# UNITED STATES PATENT AND TRADEMARK OFFICE

APPLICATION NO.	FILING DATE	FIRST NAMED INVENTOR	ATTORNEY DOCKET NO.	CONFIRMATION NO.
10/829,227	04/22/2004	Satoshi Muramatsu	252051US3 CONT	7127
22850	7590	09/24/2004		EXAMINER
OBLON, SPIVAK, MCCLELLAND, MAIER & NEUSTADT, P.C. 1940 DUKE STREET ALEXANDRIA, VA 22314			GLEITZ, RYAN M	
			ART UNIT	PAPER NUMBER
			2852

<i>Office Action Summary</i>	Application No.	Applicant(s)
	10/829,227	MURAMATSU ET AL.
Examiner	Art Unit	
Ryan Gleitz	2852

## **DETAILED ACTION**

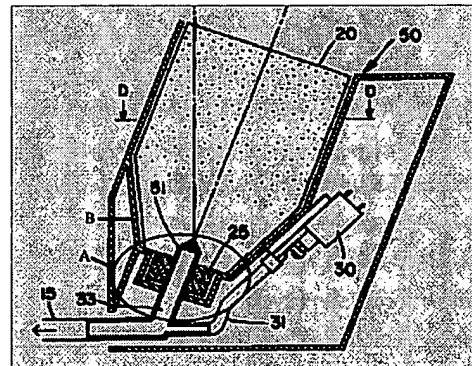
Matsumoto et al. disclose a developer container including a storing member (20) storing powder developer therein shown in the figure below taken from Figure 7 of the publication. A developer outlet (A) having a toner exhaust passage (33) as an opening from which the developer is discharged; wherein the storing member (20) is provided with a tapered portion (B) and the developer outlet (A) is formed in the tip of the tapered portion (B), and wherein the opening (33) of the developer outlet (A) is formed at an angle (theta) to the direction of gravity.

Matsumoto et al. do not disclose a shutter member fitted into the opening.

However, Yanagisawa et al. disclose a developer container in Figure 12 including a shutter member (30) for closing the opening of the developer outlet when the shutter member (30) is fitted into the opening (27). The shutter member (30) has a shaft-like configuration. The shutter member (30) is biased by a biasing member (34) from an inside toward the outside of the developer container and moveable between a closed position where the opening is blocked and an open position where the opening is unblocked. A nozzle (51) is inserted into or removed from the developer outlet, and the shutter member (30) is moved when the nozzle (51) is inserted into the developer outlet. The piston (31) of the shutter member (30) has a diameter equal to that of the nozzle ([0055], lines 6-7). A seal member (35) for closing the developer outlet has a through hole (36), and the inside diameter of the through hole is less than an outside diameter of the shutter member ([0055], lines 1-2).

It would have been obvious to one of ordinary skill in the art at the time the invention was made to modify the developer container of Matsumoto et al. with the entire shutter member mechanism as taught by Yanagisawa et al. so that the shutter member is movable in the direction of the axis of the opening of the developer unit. The suggestion for doing so would have been that Yanagisawa et al. teach that this configuration allows the piston (toner container) and the nozzle (image forming apparatus) to align with each other and to prevent toner from leaking through the toner outlet passage ([0058], lines 1-5).
